**Subject:** Exhibition – Planning Proposal Mt Gilead Stage 2

### Attachment 1 – EHG comments on exhibited Mt Gilead Stage 2 planning proposal

### **App C – Mt Gilead Stage 2 Biodiversity Certification Assessment Report and Strategy dated November 2022 (version 7)**

**Subject:** Consultation under section 3.25 of the Environmental Planning and Assessment Act 1979 for the Gilead Stage 2 State Assessed Planning Proposal

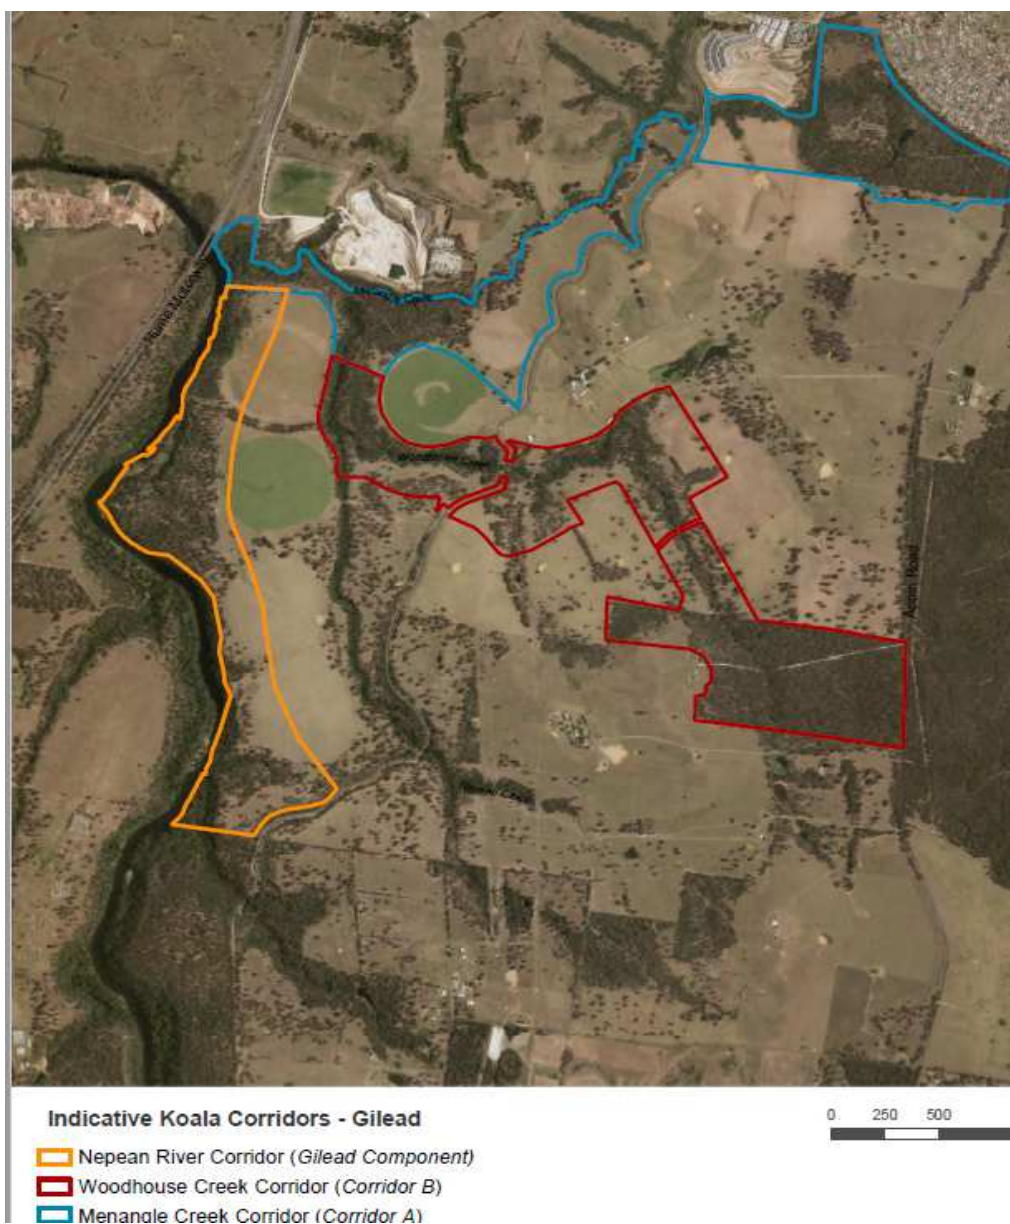
It is understood that DPE Planning provided the koala corridor map below to Lendlease on 8 December 2021 and advised that: *The map at Attachment 1 reflects the outcomes of those investigations and is the current indicative mapping for these corridors. These corridors apply the*

The Gilead Planning Report and the Biodiversity Certification Assessment Report and Strategy do not include a comparison map of the planning proposal with the DPE Planning corridors. Furthermore, an assessment of consistency with the OCSE Koala reports has not been provided.

Map 1 – Figure 4 Biodiversity Certification Assessment Report and Strategy

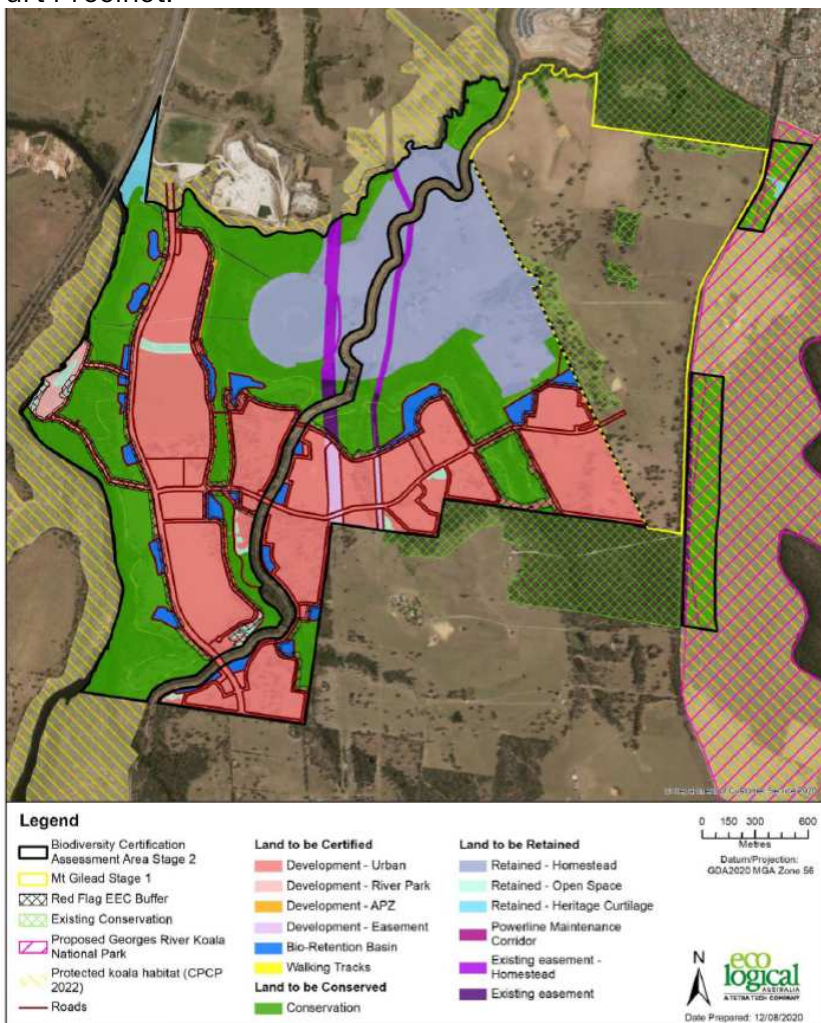
In response to the recommendations of the OCSE, the Biodiversity Certification Assessment Report and Strategy includes Figures 4 and 5 (maps 1 and 2 below) which depict several uses of land within the Koala corridors that are inconsistent with the OCSE recommendations including the Riverside Reserve, basins and asset protection zones (APZ).

Regarding the **Riverside Reserve**, the Biodiversity Certification Assessment Report and Strategy Figure 4 identifies the reserve and its access roads within the Koala corridor as ‘Land to be Certified Development – River Park’. The report also refers to the river park as “open space” and states that (p 112) *A one-way access road will link the urban area to this river frontage but will not impact riparian buffers, the area will be fully landscaped with picnic/BBQ areas and car parking.* Based on the advice provided by the OCSE including Table 1 above, the proposed Riverside Reserve including the picnic areas and access roads should not be included within the Nepean River Koala corridor. It is clear that the Riverside Reserve and its access roads are part of the proposed urban development land and not part of ‘land to be conserved’. The proposed clearing of Koala habitat to facilitate the reserve and its access roads is therefore not supported by EHG.

Regarding the **proposed basins**, they are required infrastructure to support and facilitate the urban development of the site. In considering the OCSE advice including Figures 7 and 8 above, EHG is of the view that the basins would be considered as ‘development’ and as such should be located on the development side of the exclusion fence within the development footprint. To further illustrate this point, Figure 4 in the Biodiversity Certification Assessment Report and Strategy identifies the basins as ‘Land to be Certified Bio-retention Basin’ and therefore part of the development area and not part of the ‘Land to be Conserved’. Furthermore, Table 1 states *Land proposed for Biodiversity Certification (Urban development and associated infrastructure - roads, bio-detention basins, APZs)* while Section 5.2.4 states *Stormwater runoff from urban areas will first be treated in off-line bio-retention basins before being discharged to the streams..... These bio-detention basins are all located outside of the riparian buffers and within the urban footprint.*

It appears that the basins will also result in the removal of habitat within Koala corridors, which is not supported by EHG, and there will be ongoing impacts associated with maintenance of the basins. The basins in the Koala corridors are also excluded from the proposed Gilead BSA site. Furthermore, the CPCP does not include certified areas for basins within Koala corridors in the Appin Part Precinct. Therefore, EHG believes the proposal to certify basins within the Koala corridors is inconsistent with the Koala corridor conservation approach in the CPCP for the Appin Part Precinct.

- EHG does not support the proposed certification (i.e., 'Land to be certified') of the Riverside Reserve (and its access roads), basins and APZs within the Koala corridors. These uses are inconsistent with the OCSE recommendations and will significantly reduce the width and function of the corridors, in addition to the area available for revegetation. The free passage

## Map 2 – Figure 5 Biodiversity Certification Assessment Report and Strategy

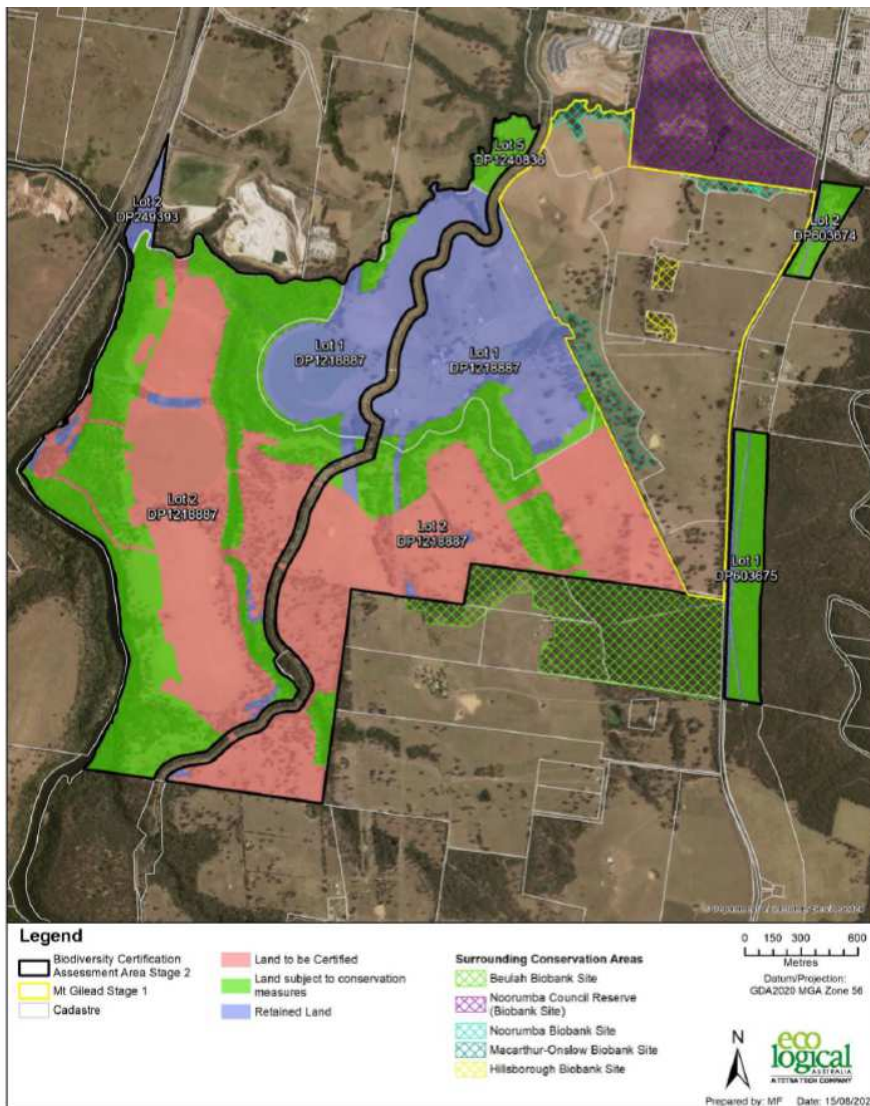
EHG raises concerns that the **Koala corridor boundaries and location of buffers** as per the OCSE requirements have not been identified on maps. EHG notes there are areas where the corridor boundary line cuts off existing Koala habitat resulting in part of the existing habitat being located within the Land to Certified. As stated by the OSCE:

Therefore, the Koala corridor boundaries should be revised to ensure that existing habitat that forms part of the corridor is conserved and not severed/cleared through their inclusion in the

proposed certified area. The Biodiversity Certification Assessment Report and Strategy maps should also include the corridor width measurements and the location of the buffers as recommended by the OCSE.

- As discussed above, the Koala corridor boundaries should be refined and the location of the buffers depicted on maps, as per the OCSE requirements. Maps should also show Koala corridor width measurements (consistent with the OCSE requirements) and allow for a comparison with the DPE Planning Koala corridor map.

Figure 4

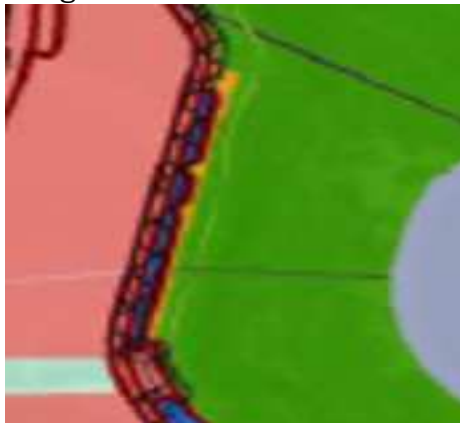
Regarding **APZs**, as depicted in Figures 4 and 16 (see excerpts below), it appears that part of the APZ is located within the Koala corridor and is identified as 'Land to be Certified Development-APZ' which is inconsistent with the OCSE recommendations and not supported by EHG.
